CONSOLIDATED EDISON COMPANY OF NEW YORK, INC.

Indian Point Station, Unit No. 2

Applicant's Responses to Round Two Questions  
Submitted by The Citizens' Committee for the  
Protection of the Environment (Set H)  
on March 9, 1971

March 31, 1971

Fig. 29-1 High Altitude Flights Within 10 Miles of Indian Point.  
 (From N.Y. Center VOR Peak Day Chart, Sept. 5, 1969)

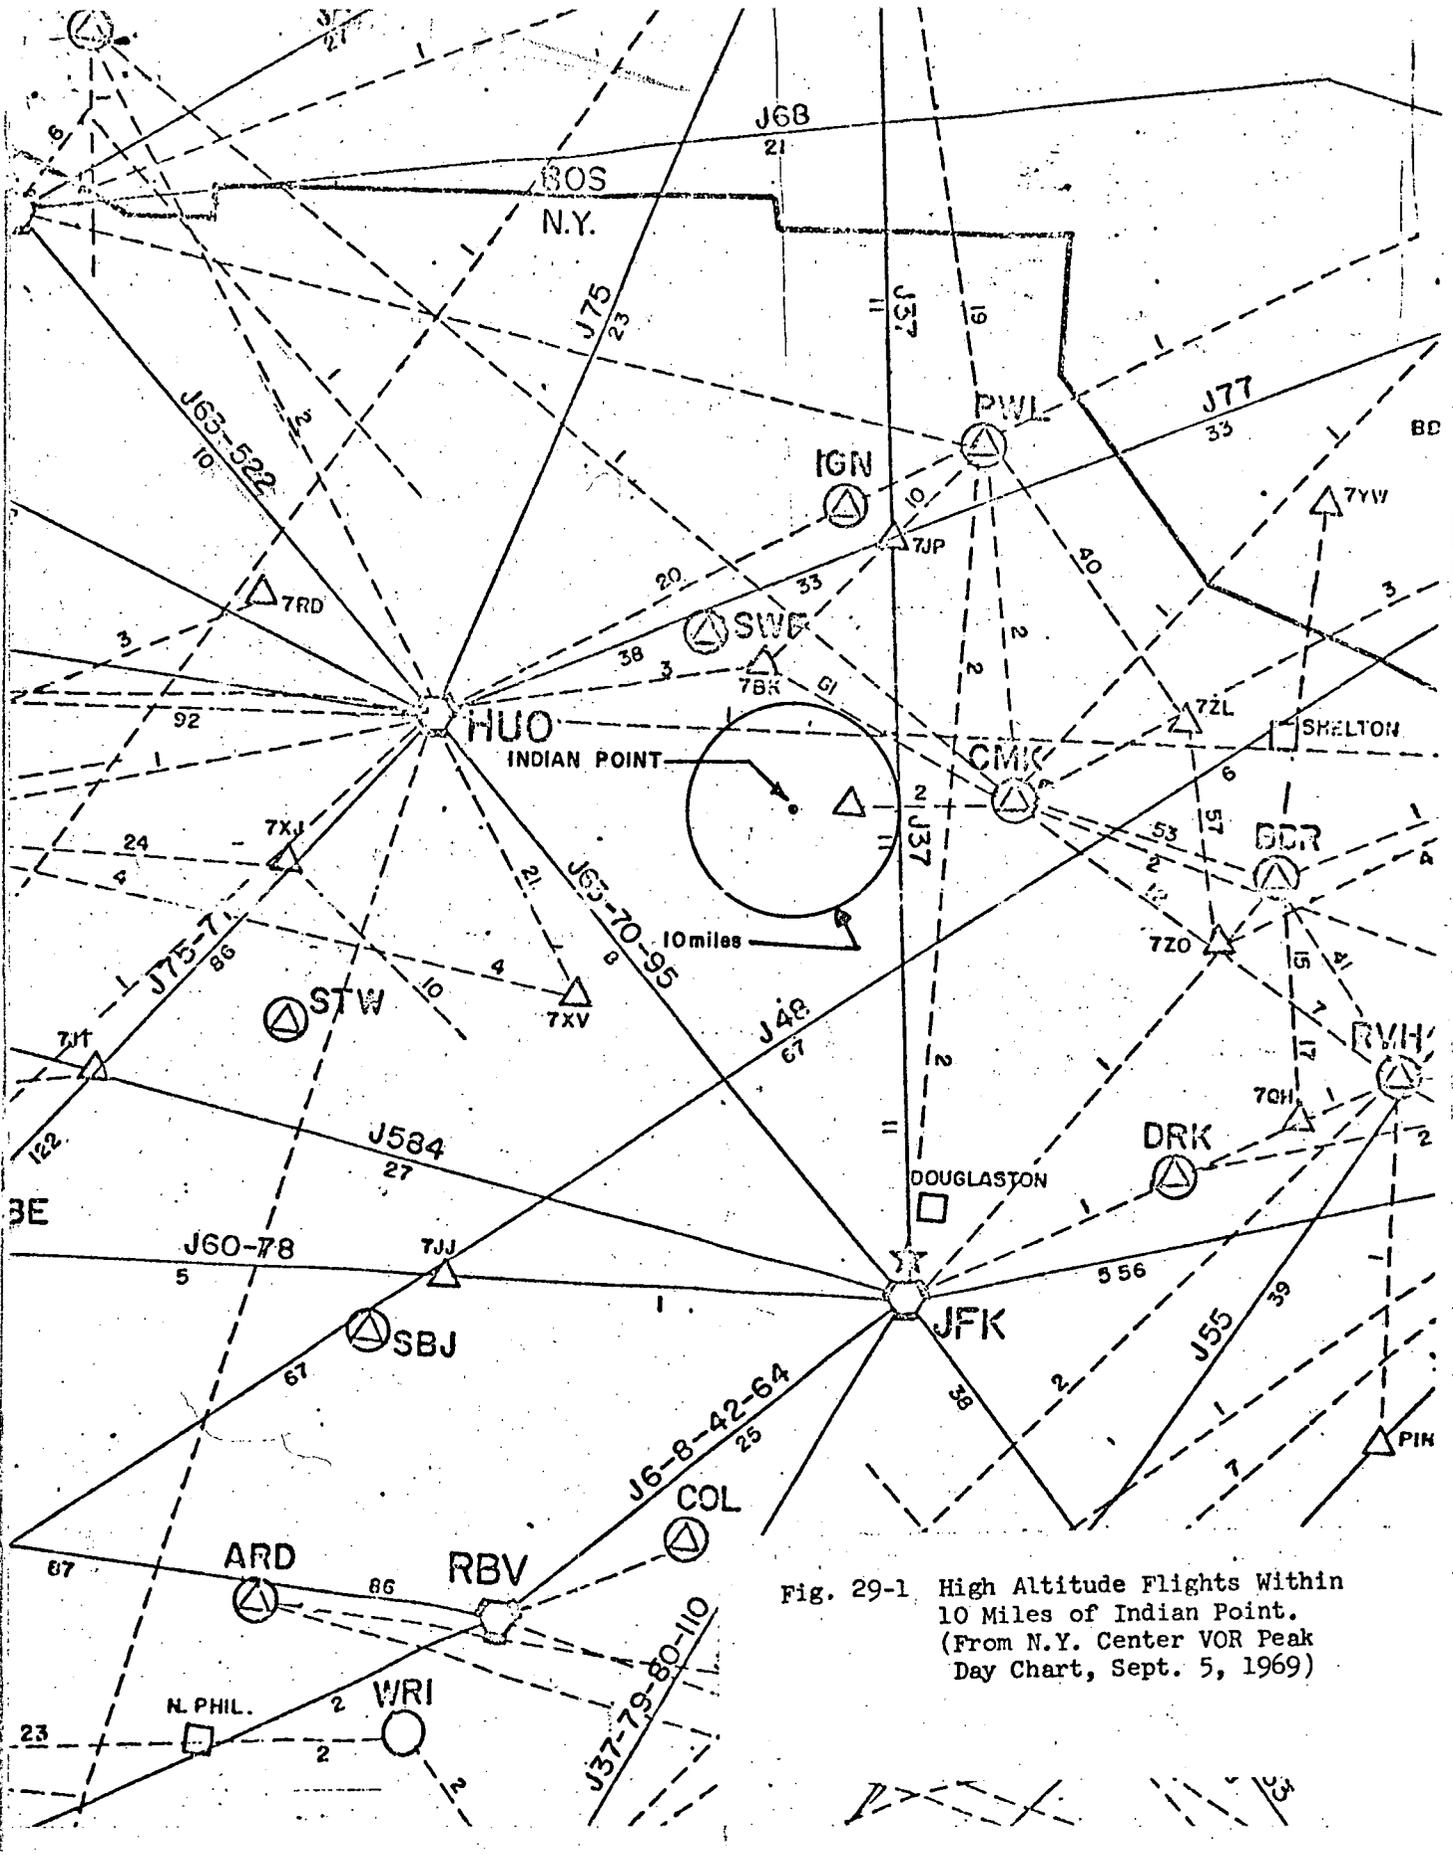
- a. Show flight routes and holding patterns for all three major New York airports as well as the Westchester County airport for all routes and holding patterns within a 10 mile horizontal distance from Indian Point. If you are unwilling to answer because you believe 10 miles is too large explain in detail your reasons and answer the question for the acceptable distance.
- b. Indicate with respect to these routes the average number of airplanes on the route each year and their average altitude.
- c. Indicate the number of mid-air collisions between airplanes one of which will land or has taken off from the airports involved, in the last ten years.
- d. Indicate what data was obtained from which FAA officials with respect to your inclusion that the crash of an airplane into the reactor is so incredible that no analysis of the effect of that accident is required.

Answer: a. The flight routes within 10 miles of the Indian Point Plant are shown on Figures 29-1\*, 29-2\*, and 29-3\*. The Brewster holding pattern shown on Figure 29-4\*\* serves Westchester Airport, which is used primarily by smaller aircraft (BAC-111 and FH-227 type aircraft). The New York Metroplex is shown in Figure 29-5.

\* These are portions of the New York Center VOR Peak Day Charts, September 5, 1969, obtained from the New York Center for air traffic control, on which Applicant has located Indian Point and a 10 mile radius circle.
